1. 7:00 P.M. Planning Commission October 2020 Regular Meeting

Agenda
Planning Commission - Virtual Meeting
Wednesday, October 21, 2020 – 7:00 P.M.

- Medical & Recreational Marihuana Zoning Text Amendments.
 - Public Hearing
- Site Plan Review: Avenue Market at 902 W Michigan.
- Special Use Permit & Site Plan Review: 201 N Park.
 - Public Hearing

**DEMOLITION
SITE PLAN**

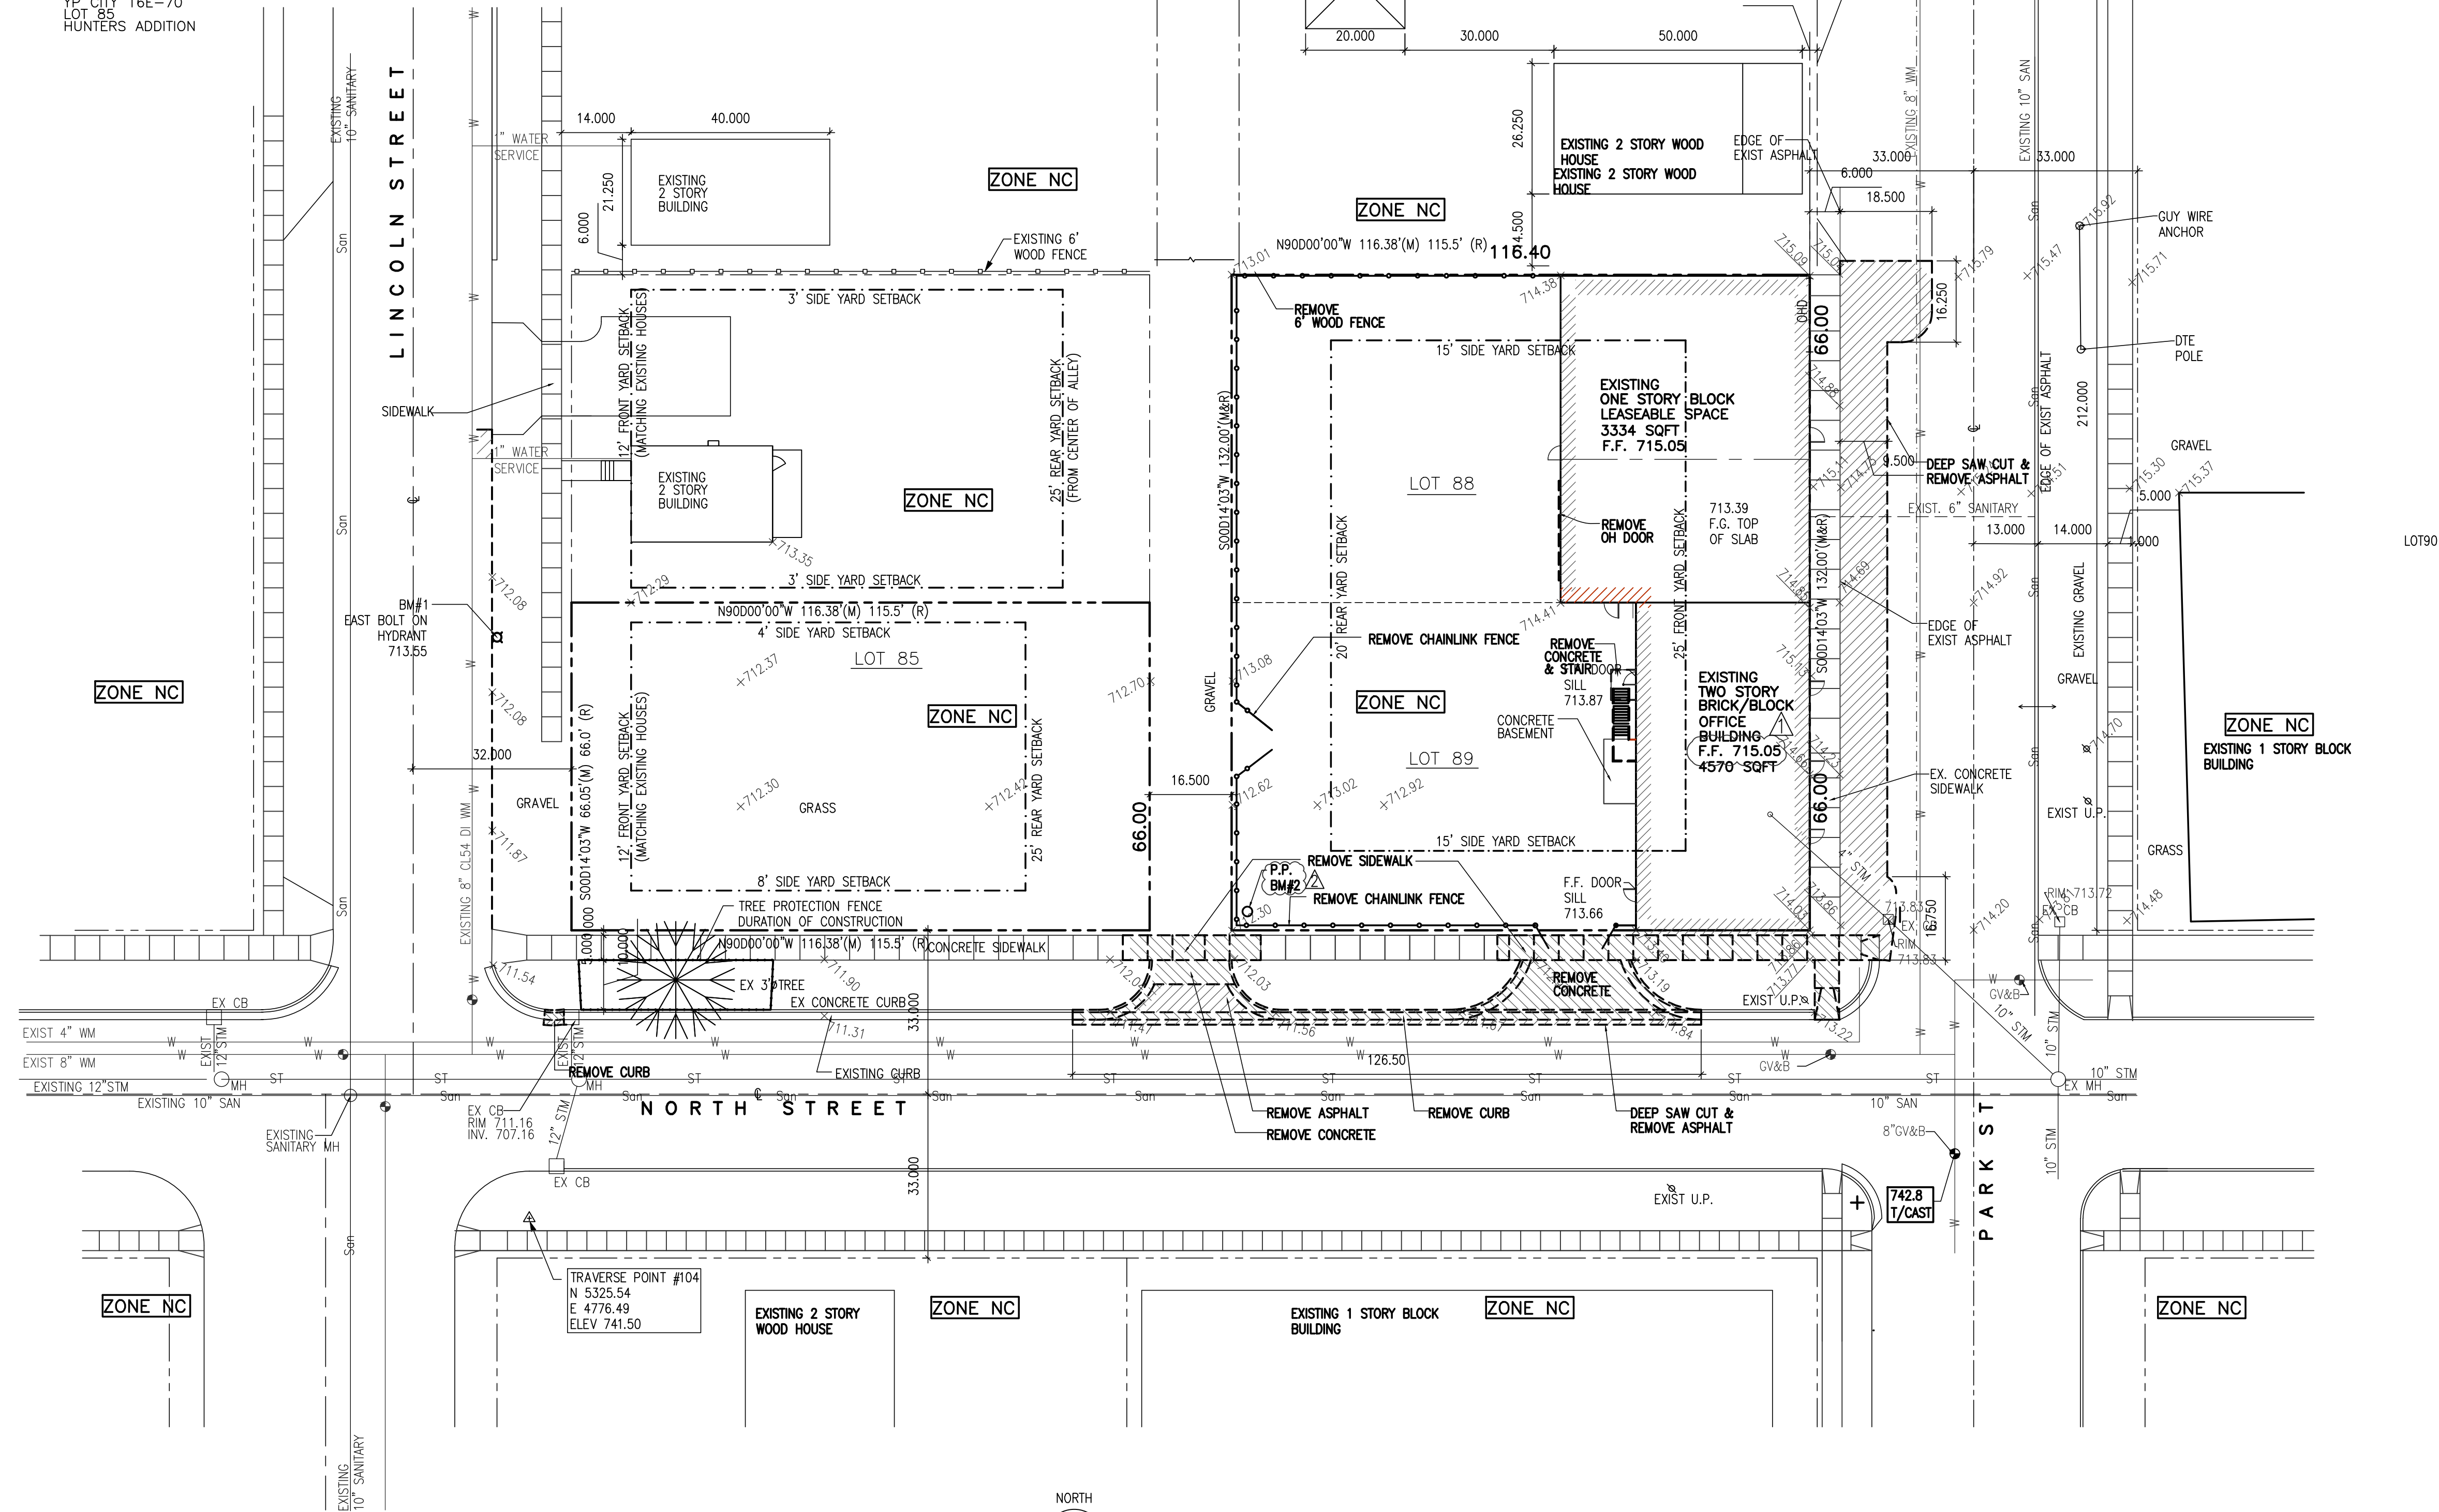
2. On sheet C-2 Demolition Site Plan, the removal hatch should be added to the sheet legend for clarity.
3. On sheet C-3 Site Layout Plan, the proposed surface hatches should be added to the sheet legend for clarity.

2. On sheet C-2 Demolition Site Plan, the removal hatch should be added to the sheet legend for clarity.
 - a. (Answer): Has been clarified.
3. On sheet C-3 Site Layout Plan, the proposed surface hatches should be added to the sheet legend for clarity.

SHEET TITLE:
SITE DRAINAGE PLAN

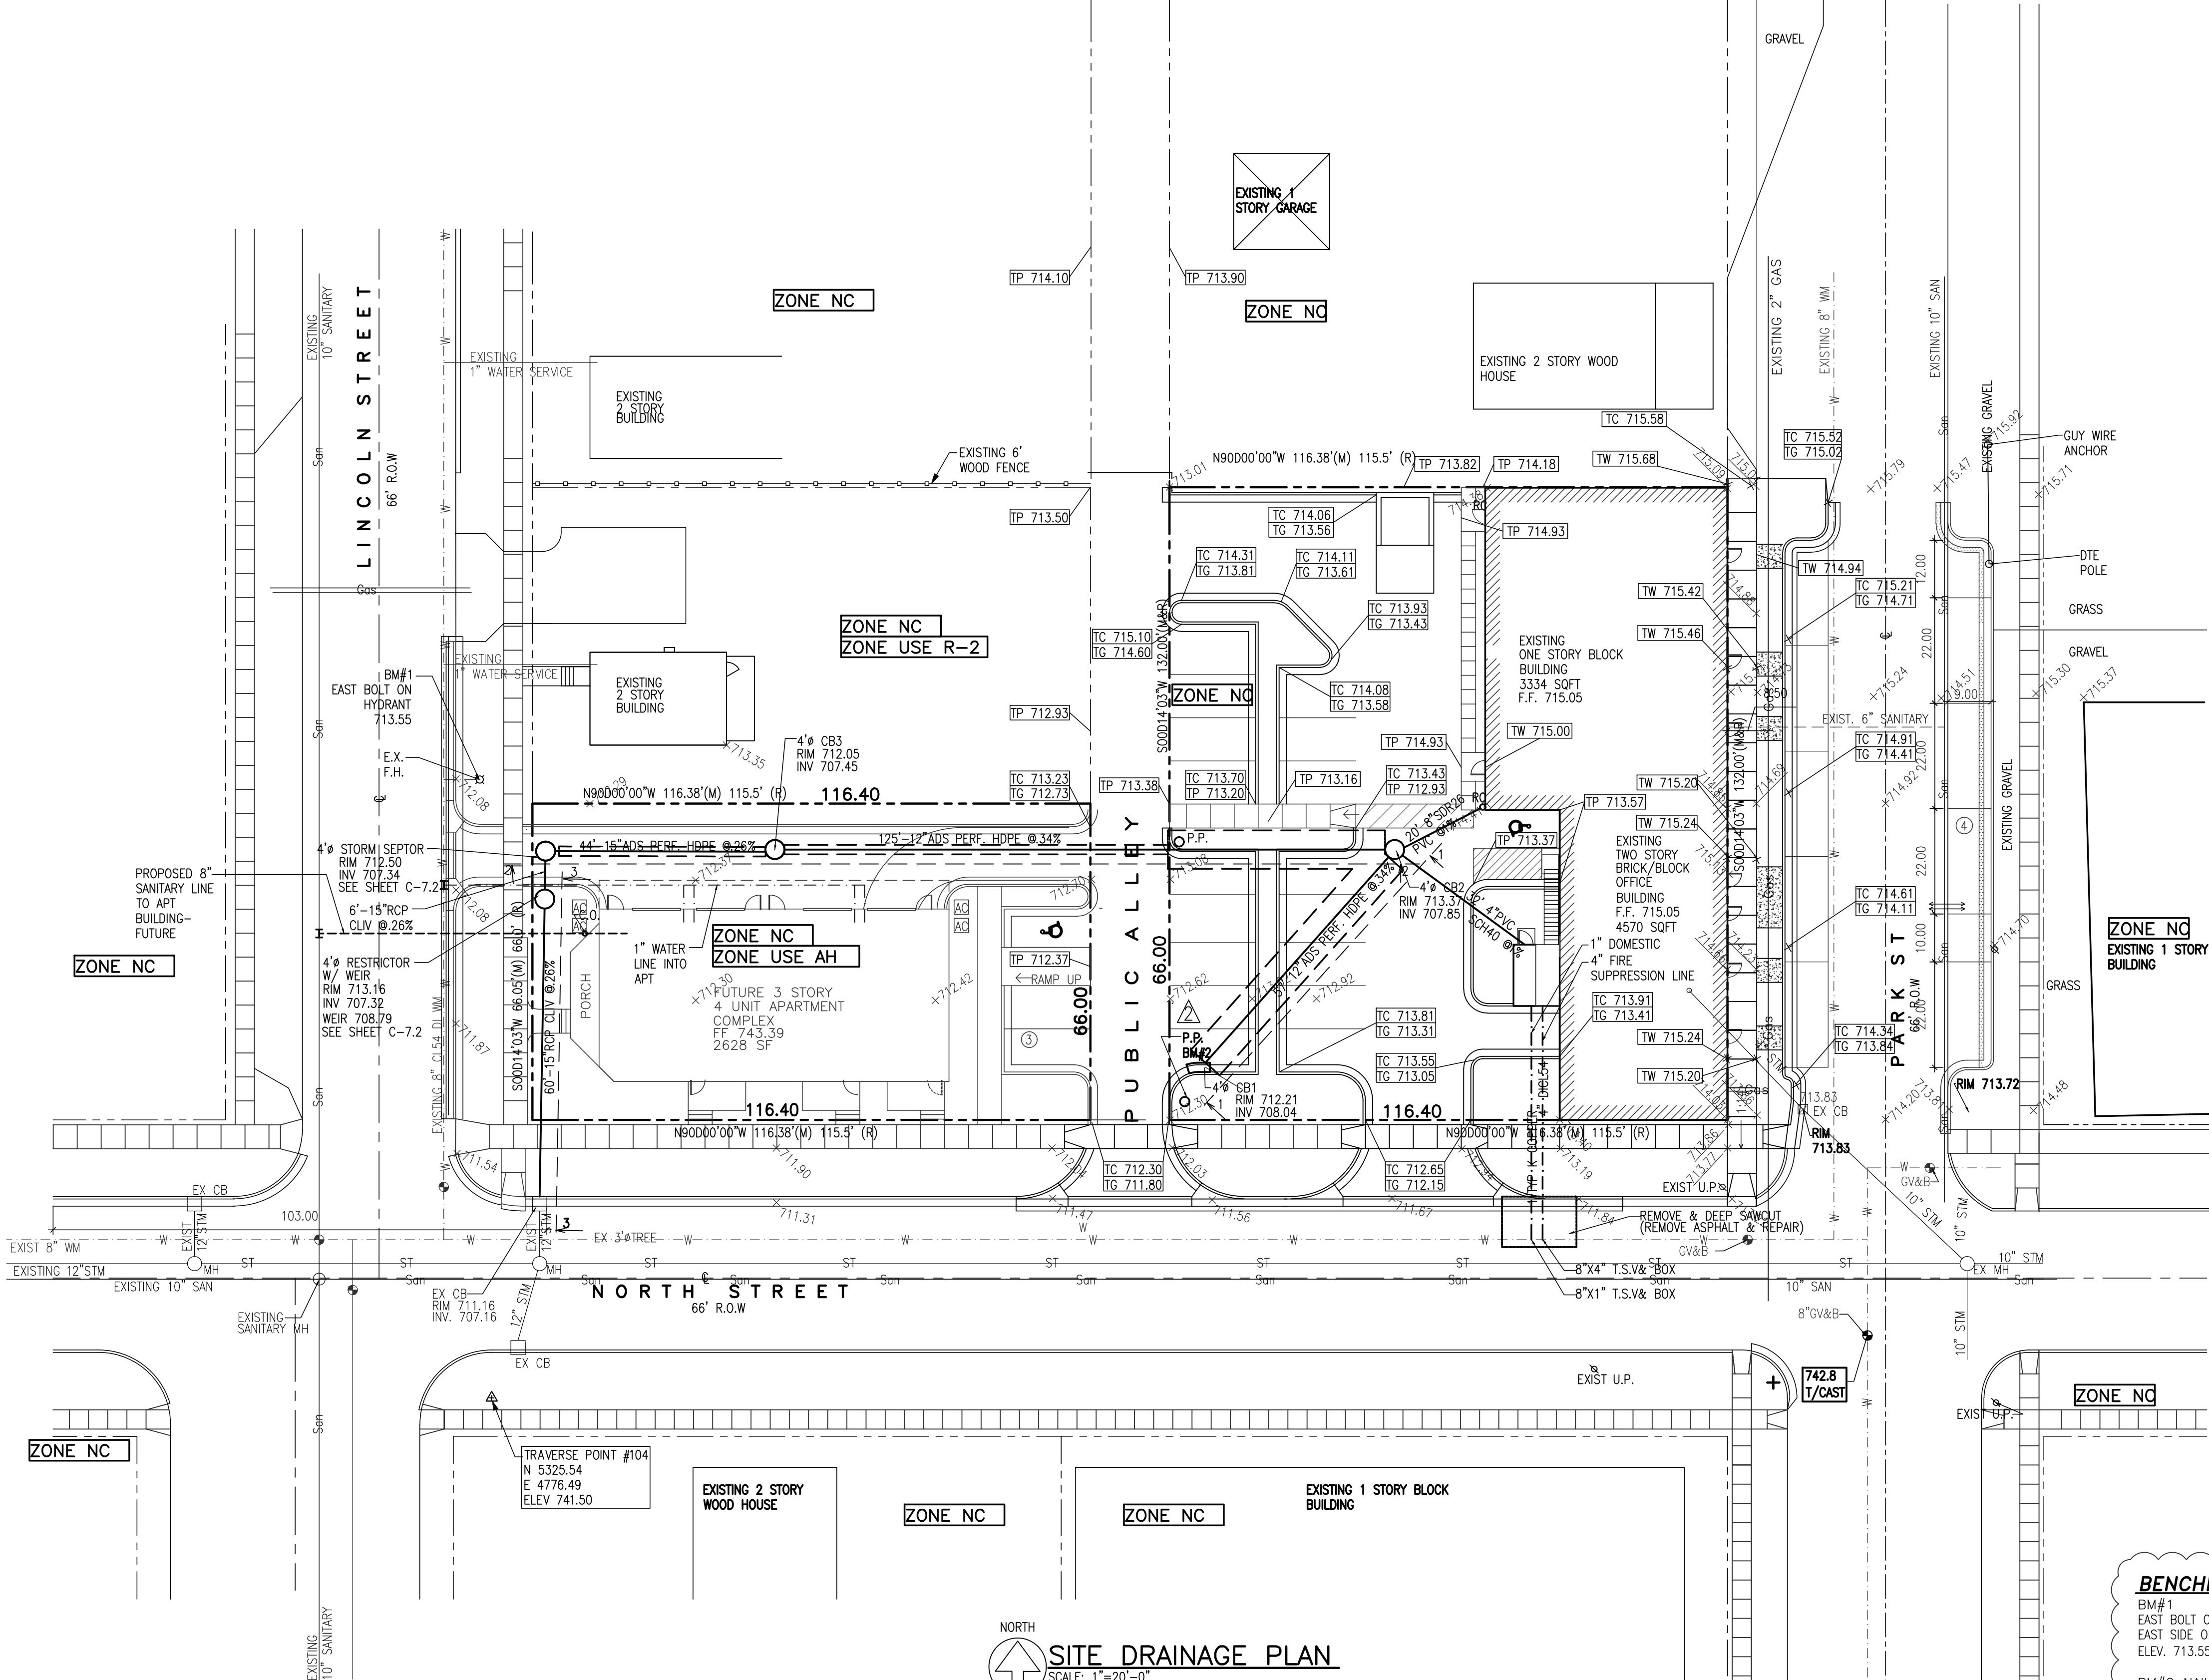
11. Brick paver pavement cross section detail should be provided on the plans as well as proposed flagpole foundation detail.
12. Remove note on sheet C-4 Site Drainage Plan that says “Existing 6-inch” with a leader pointing to the existing water main along North Street. The water main is 8-inches diameter. Any improvements to the water or sanitary sewer systems will require review and approval from YCUA.

- a. (Answer): There is no brick paver pavement on plans and flag poles have been eliminated on project.
- 12. Remove note on sheet C-4 Site Drainage Plan that says " Existing 6-inch" with a leader pointing to the existing water main along North Street. The water main is 8-inches diameter. Any improvements to the water or sanitary sewer systems will require review and approval from YCUA.
